# City of High Point North Carolina

## ***BID ADDENDUM***

**Bid Number: TRANSIT-120216-B-0004**

Transit Vehicle Decal Production & Installation

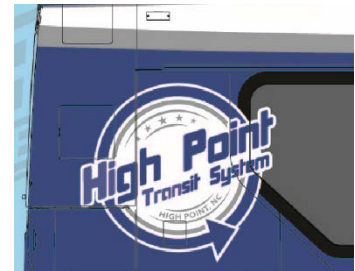
2. On the small High Point Transit System logo that's on the side (toward the rear of bus) can it all be printed on IJ 180Cv3? The area across the window is so very small and at the rear edge the Cv3 will hold up better. **Yes, this entire logo can be printed on IJ180Cv3**
